# Sub-Technical Repercussion Sheet

A350-XWB	<b>L90032</b>	STATUS: OFFICIAL(Full TRS)
XW CEF		ISSUE: 6
		OFFICIAL DATE: 12-Apr-2018

<b>TITLE:</b> Air Conditioning - Temperature Control And Monitoring - Move Cabin Temperature Sensor From Basic To Alternative Position In Zone 5	<b>ATA:</b> 2161	<b>SUB-TRS MAIN IMPACTED ATA:</b> 2123
	<b>COORDINATOR:</b> FACCA Kelly	
<b>REASON:</b> Request for Product Customization - Customization Administrative Issue - SY-Other Systematic Action ;

PRE-MOD: Temperature sensor in basic position (FR59)

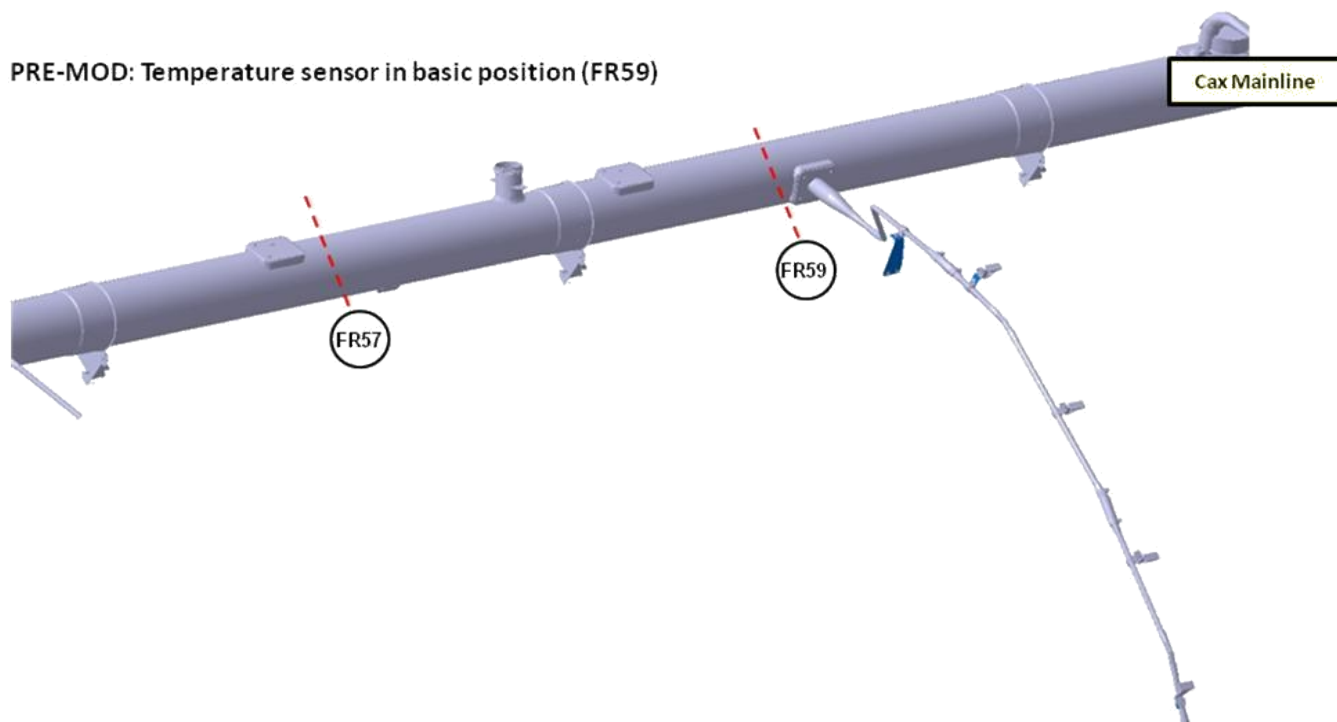
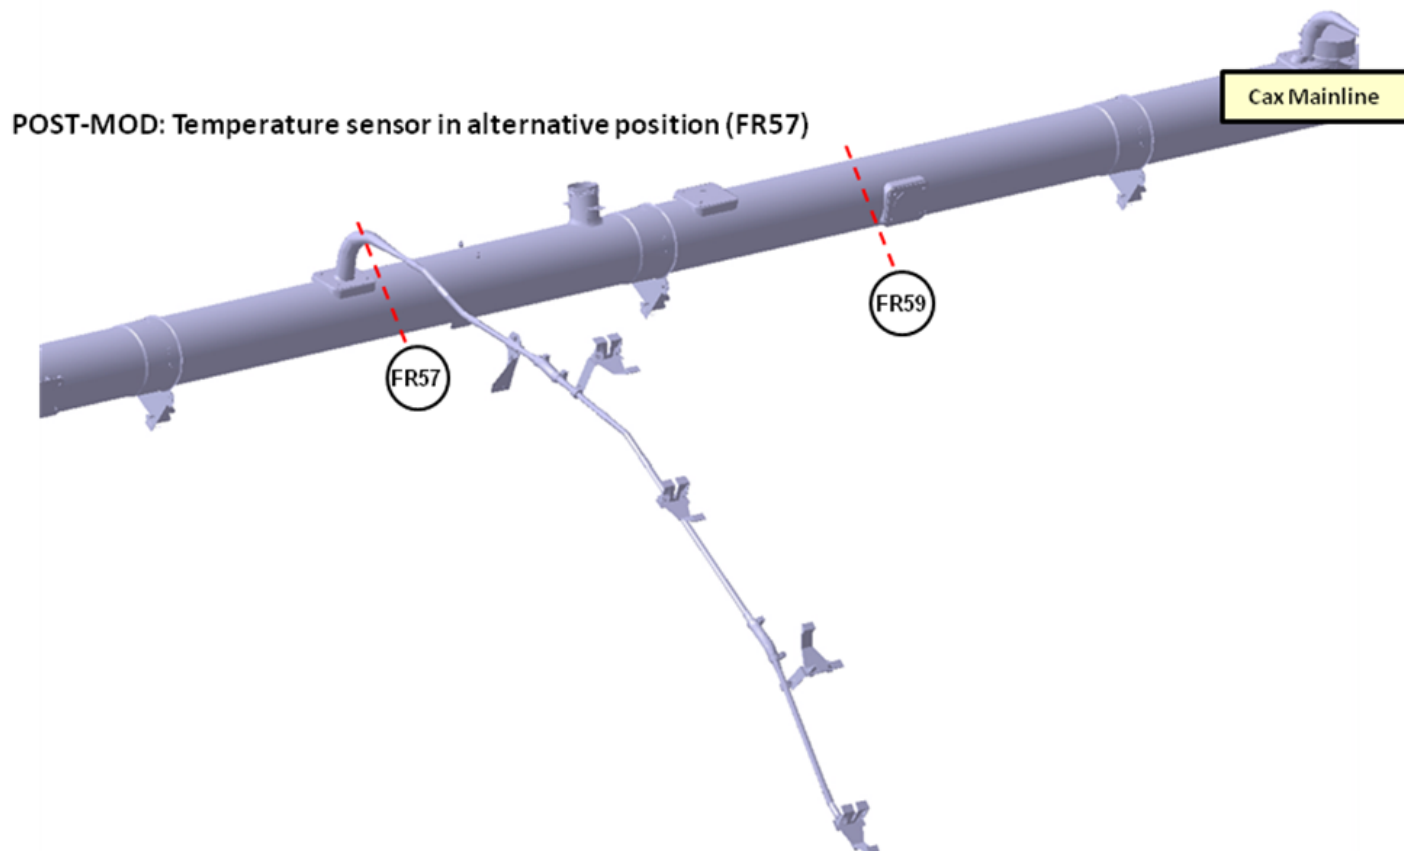
Temperature Sensor is moved from basic position (FR59) to alternative position (FR57)

Sketch CEF\_ESI\_HAR\_EQT\_1

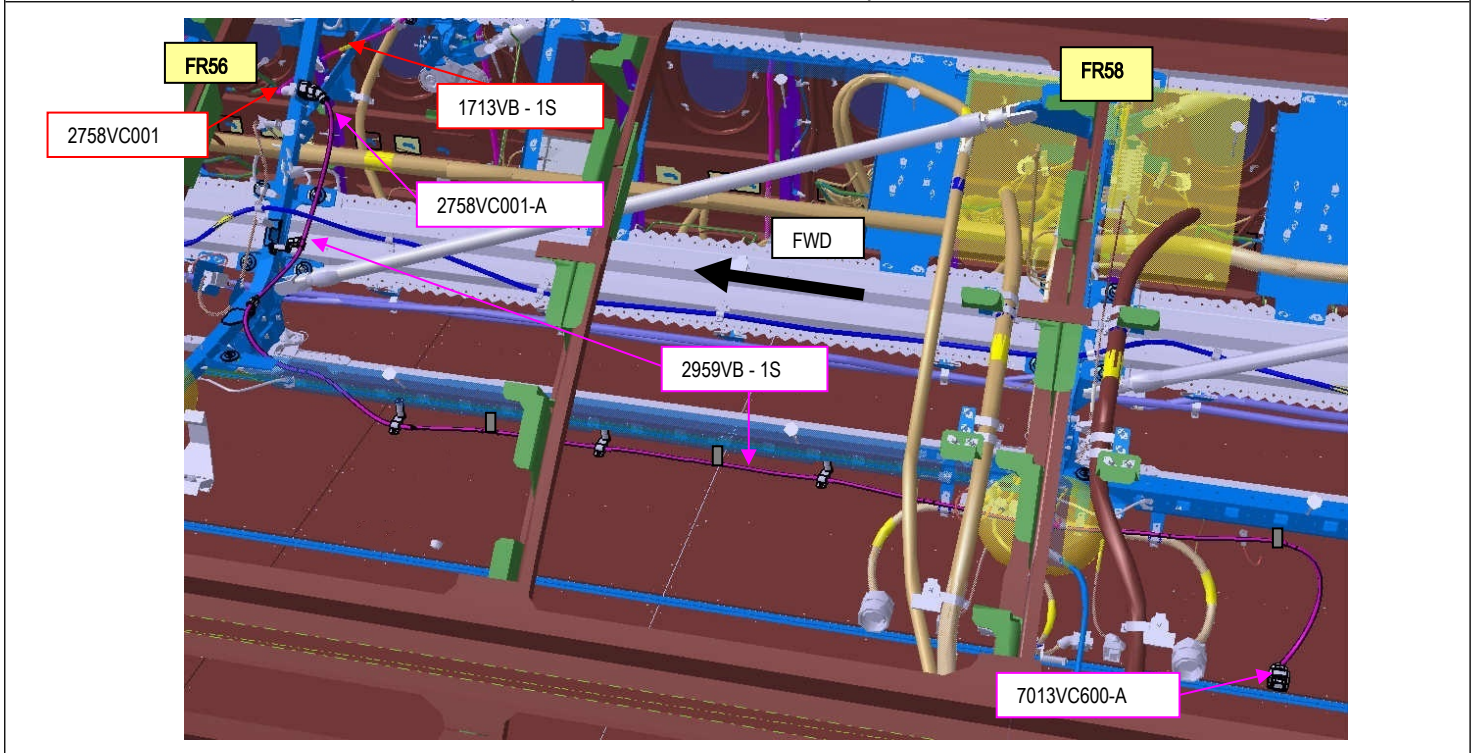
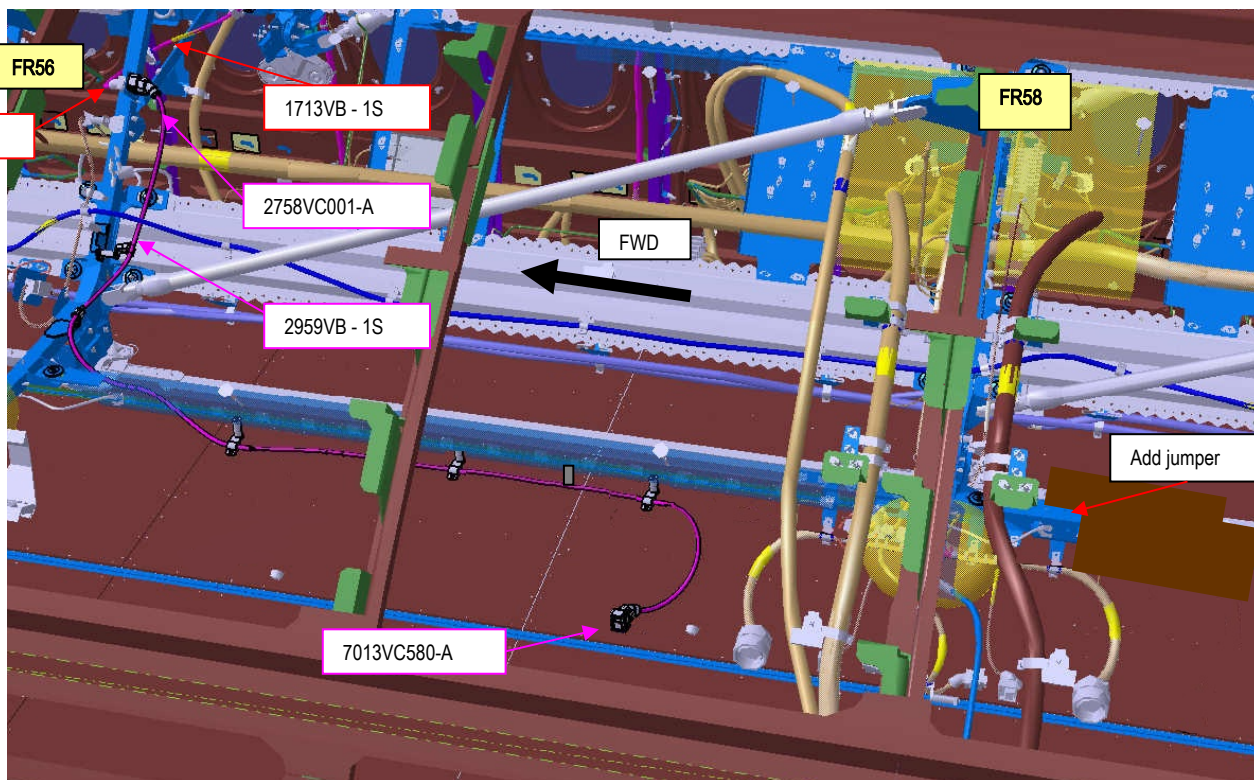
For new routing Temperature Sensor in alternative position remove 3 clamps and 3 spacers between FR59 and FR56.  
(See sketch 1)

Temperature Sensor in basic position

Temperature Sensor in alternative position
